INSTRUCTION TO SERVICE

ITS: 59173		10-Feb-2021
SECTION:	219-Engine and Transmission	
WRITTEN BY:	Mike Pearson	
SUBJECT:	Inspect and replace BAE ISG mounting bolts	
ISSUE:	Existing ISG mounting bolts may be loose due to initial incorrect torque.	
SUMMARY:	ISG mounting bolts need to be replaced and installed with correct torque

Figure 1: HV Cable Support Bracket Mounting Bolt Locations

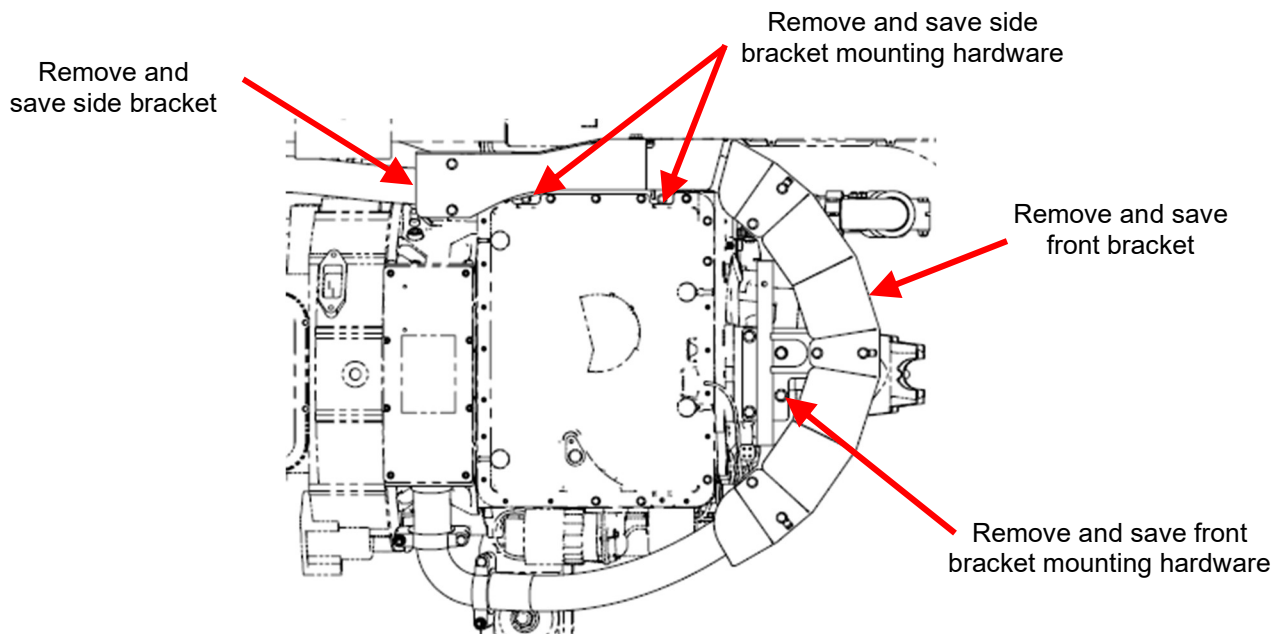
1. Set park brake and chock wheels.
2. Turn the main battery disconnect switch to the "OFF" position and lock out.
3. If necessary, raise coach in accordance with the New Flyer Service Manual.
4. Removal of the HV cable brackets may be required, this will allow room to access the ISG mounting bolts number 10 and 5, see Figure 1 for bracket bolt locations.

10. Repeat for the 9 remaining ISG mounting bolts, removing one bolt at a time in a star pattern.
11. Reinstall the side bracket if removed in Step 4, in the same location and orientation as removed and torque existing hardware to 5 to 7 ft lb.
12. Reinstall the front bracket if removed in Step 4, in the same location and orientation as removed and torque existing hardware and torque to 44 +/- 4-ft lb.
13. If necessary, lower coach in accordance with the New Flyer Service Manual.
14. Remove lock out and switch the bus on, then return the bus to service.

Figure 2: BAE ISG Mounting Bolt Locations

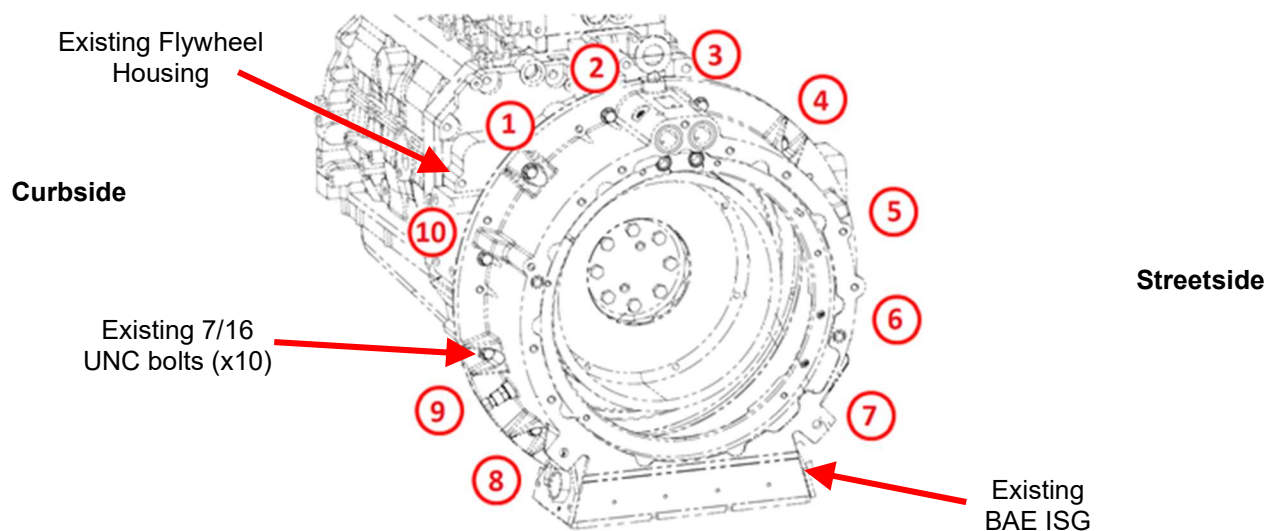
5. Locate the BAE ISG mounting bolts as shown in Figure 2.

⚠ WARNING: If **ALL 10** bolts have torque stripes and **ALL 10** torque stripes are aligned, continue to the next Step. If **ANY** bolt is broken or has a missing or broken torque stripe, hold the bus from service and **contact your New Flyer RPSM for further instructions.**

6. Remove one bolt at a time in a star pattern.
7. Use a thread chaser to clean the threads in the bellhousing, then use a blow gun to spray compressed air into the hole to clean the hole of any old Loctite or sealant.
8. Apply Loctite 243, p/n 081034 to the new bolt threads p/n 10B07032 and the internal threads of the mating holes in the flywheel housing and install.
9. Torque the new bolt to 59 +/- 5.9 lb-ft. and torque seal the bolt. See Figure 3 to show how the torque seal must be applied.
